**MEMPHIS AND SHELBY COUNTY OFFICE OF PLANNING AND
DEVELOPMENT
STAFF REPORT**

CASE NUMBER: U.V. 08-09 **L.U.C.B. MEETING:** October 9, 2008

REQUEST: Automobile Parking Lot **AREA:** 0.207 Acres

Proposed Site Plan

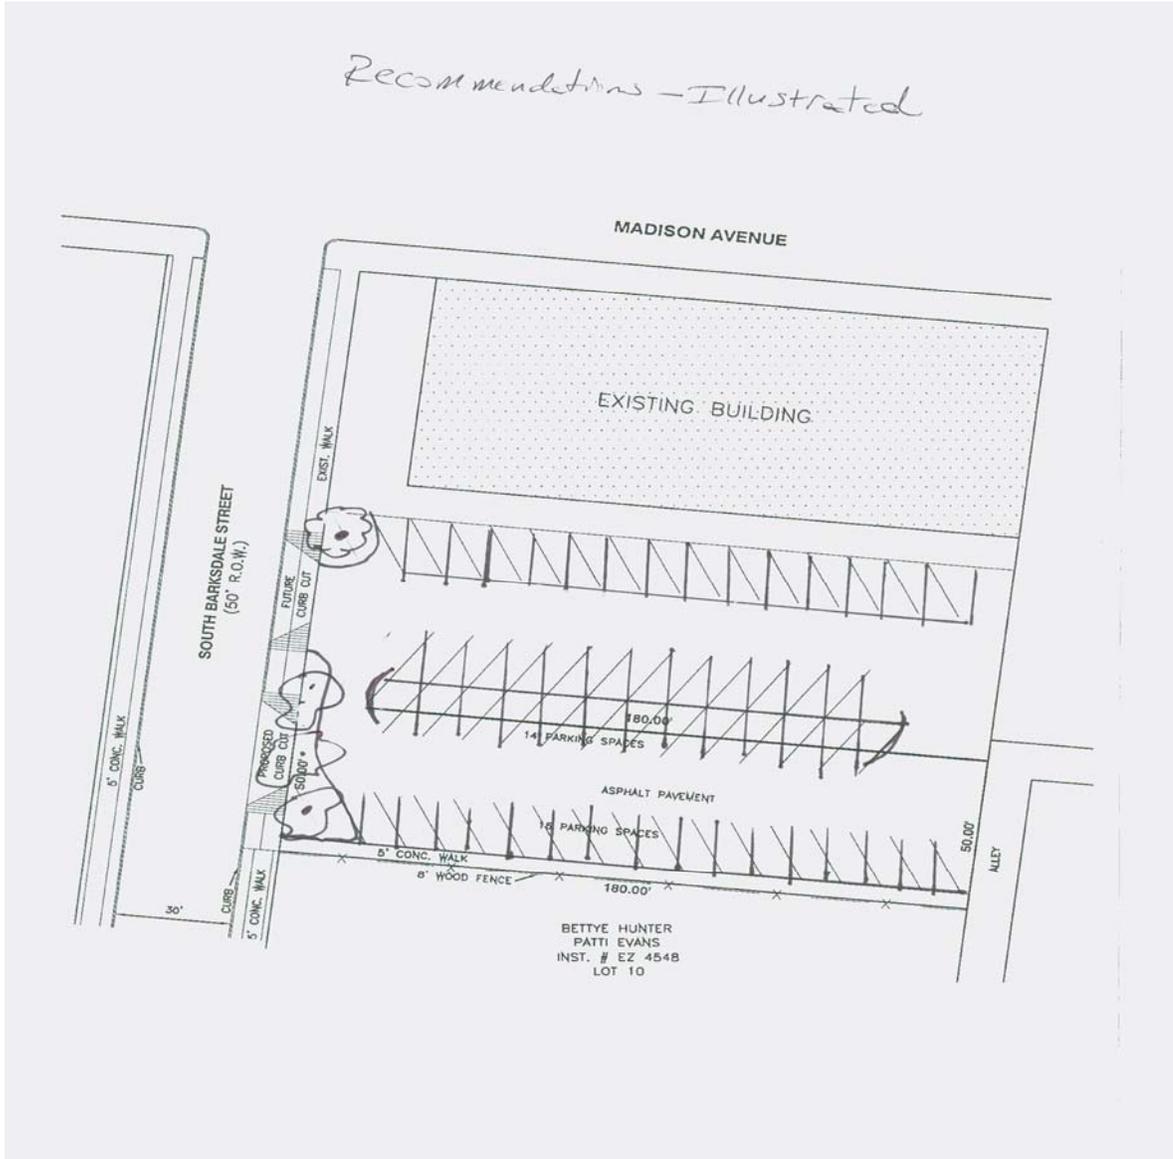
It is the opinion of the staff that further revisions to the site plan are needed before the staff can recommend this request for a Use Variance. The two proposed curb cuts are too close together and set up both parcels to function independently of each other. As this is parking for one use, the two areas should be interconnected and work together.

The addition of the second cut for the subject site, precludes the inclusion of landscaping which is required under the current ordinance. Since this development is undergoing significant renovation, it makes good planning sense to bring this site up to current standards to the extent that is possible.

The staff is mindful however, that some requirements may require modification. Current landscaping requirements require a landscaping and screening where a parking lot abuts residential zoning. The addition of the standard landscape plate would hinder the ability to provide the necessary parking spaces. In this instance, since fencing has been in place for some amount of time, and there is a 5 foot wide sidewalk along the south property line that would have to be removed, the staff recommends replacing or adding to the existing fence.

- Revise the site plan to omit the southernmost curb cut
- Re-angle the parking spaces to 90 degrees
- Provide a drive aisle at the east and west ends of the subject tract to connect with the parcel to the north
- Provide a landscaped area to run parallel with S. Barksdale Street beginning at the south end of the north curb cut and continuing southward to the south property line of the subject tract. Landscaped area shall be the equivalent of the A-1 Plate, approximately 10 feet in width. Location and materials within the landscaped area shall be subject to the review and

- In lieu of the standard B plate along the south property line the applicant shall be permitted to 1. Reconstruct the fence with a six foot tall shadow box style fence with cap, or attach a new partial fence to the existing fence to hide the braces (this new face will be a shadow box style fence with cap).
